OXFORDSHIRE COUNTY COUNCIL'S RESPONSE TO CONSULTATION ON THE FOLLOWING DEVELOPMENT PROPOSAL

Application no: 22/00747/OUT

Proposal: Outline planning application for the development of up to 370 homes, public open space (including play areas and woodland planting), sports pitches and pavilion, drainage and engineering works, with all matters reserved (appearance, landscaping, layout and scale) except for vehicular and emergency accesses to Bicester Road.

Transport Schedule

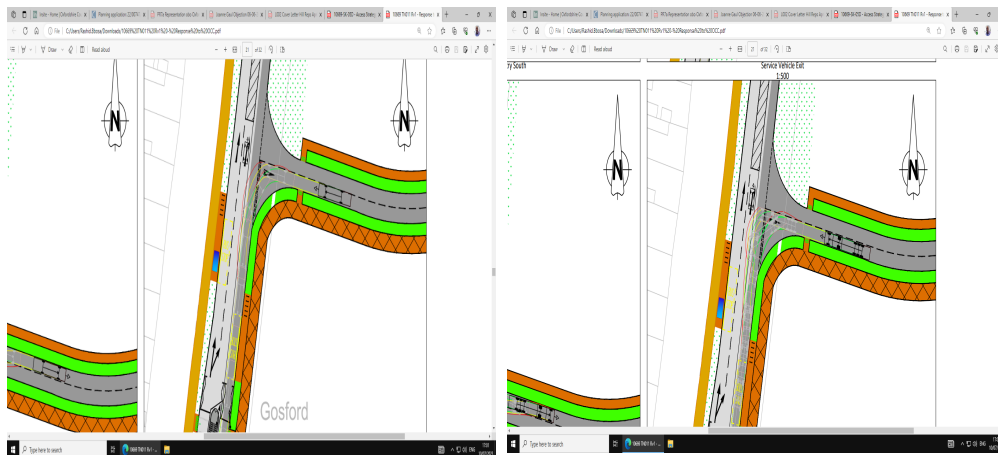
Para 3.5 acknowledges that the swept path drawing exercise was excluded in the previous submission. This has now been appended to the TN, reviewing which I note that the left-out manoeuvres cannot be safely completed in event of waiting right turning vehicles. To address this, it is suggested that the first 15m of the access need be widened to 5.5m. Alternatively, amendments to the access arrangement that take the form of a localized widening of the carriageway to ensure such vehicles can safely egress. **(Reason for objection)**

The illustration below shows the detail of the planned corridor improvements that have been drawn as part of ongoing discussions with PR6a development.

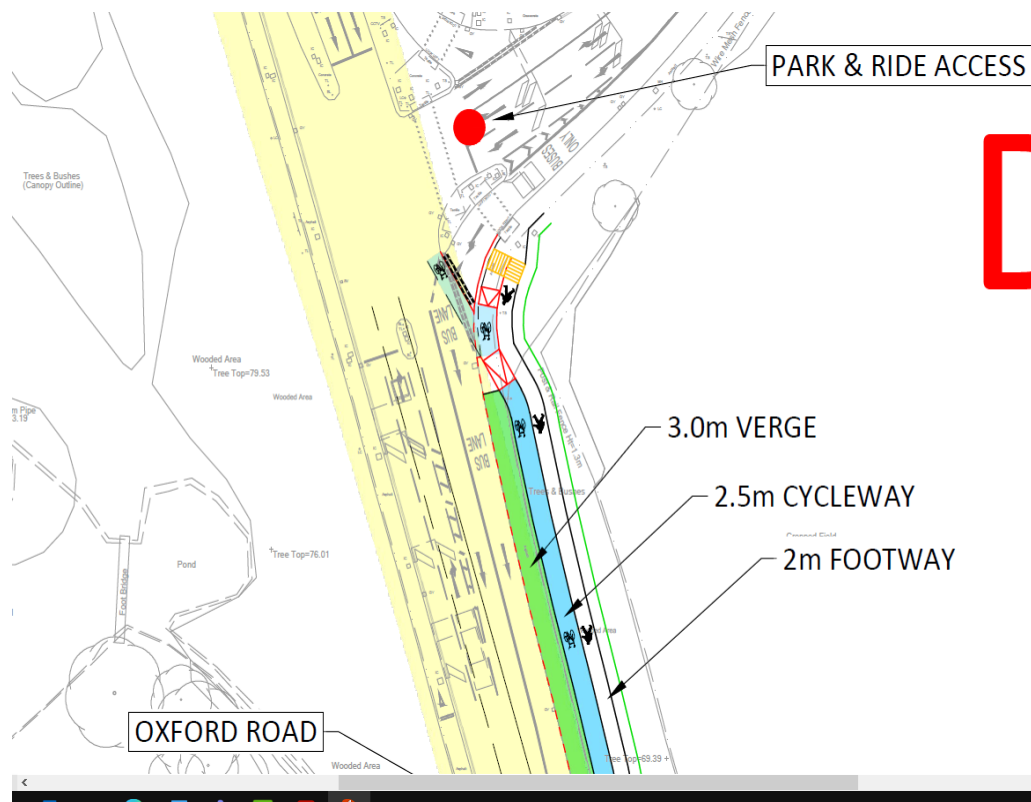
This TN and indeed the previous submission have not dedicated any meaningful improvements to the existing active travel infrastructure in a way that will encourage walking and cycling trips between the development, Oxford Parkway Park and Ride and beyond. The development is thus expected to deliver along the eastern side of the carriageway, the section between Kidlington roundabout and the entrance to Oxford Parkway station entrance. The remainder of the scheme (i.e., from the Oxford Parkway access) to Cutteslowe roundabout shall be delivered by both PR6a and PR6b.

It is essential that a consistent, timely and co-ordinated delivery of these corridor improvements is achieved with these allocated developments via the various s278 deeds.
